Doris Mendiola - OCNGS EIS comments

From: Eugene Creamer <kb2gz@optonline.net>
To: <OysterCreekEIS@nrc.gov>
Date: 09/11/2006 12:43 AM
Subject: OCNGS EIS comments

Michael Masnik, Environmental Project Manager

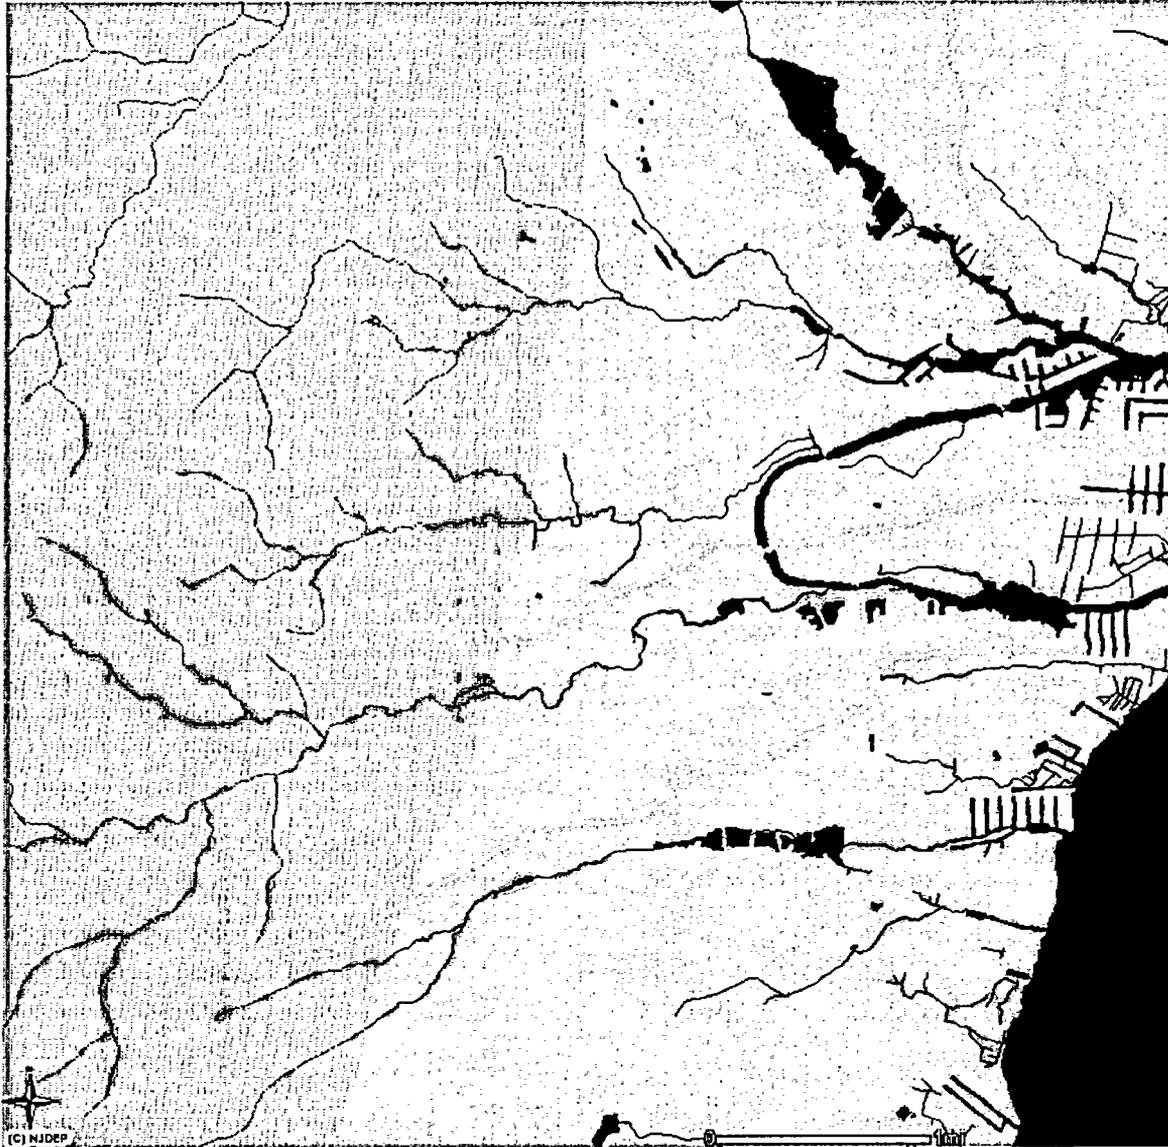
Figure 2-3 (OCNGS site boundary map), on page 2-4, delineates both Oyster Creek and the South Branch Forked River west of the Station with dotted lines. (Usually, dotted lines indicate watercourses of an intermittent nature). The USGS quad for the area delineates both streams with solid blue lines, well beyond the Garden State Parkway to the west. The NJDEP maps indicate that both streams are watershed of the Pinelands National Reserve,
